Customer No.: 31561  
Application No.: 10/063,737  
Docket No.: 8727-US-PA

**In The Drawings**

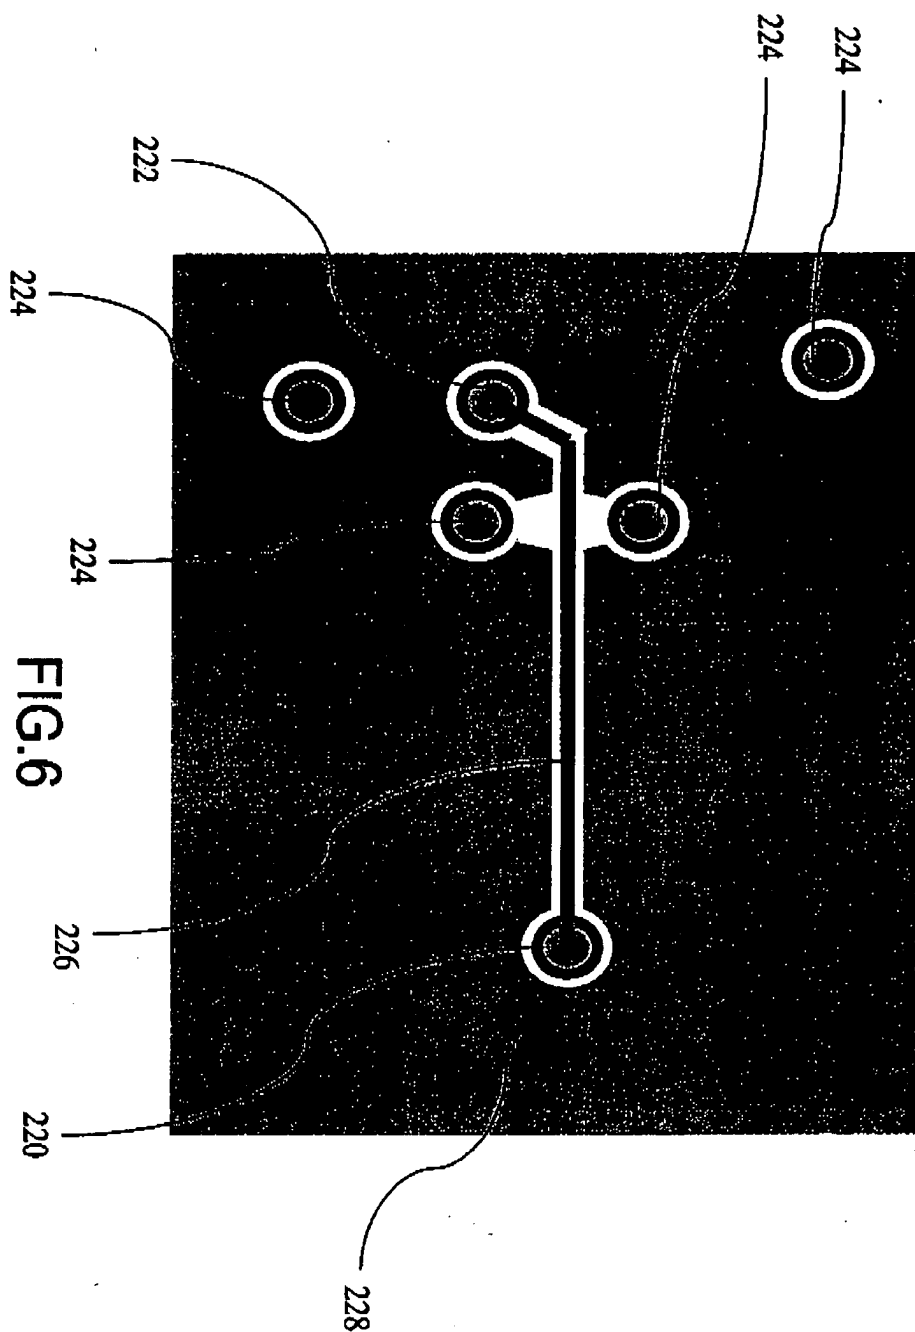
The Applicants have amended FIGs. 5, 6 and 7 for including technique features cited in the previously presented claim 16 and newly added claims 27-33. The technique feature in the claim 27 is described in the embodiments and the definition of a reference voltage, which should be a constant voltage. Therefore, no new matter is added.
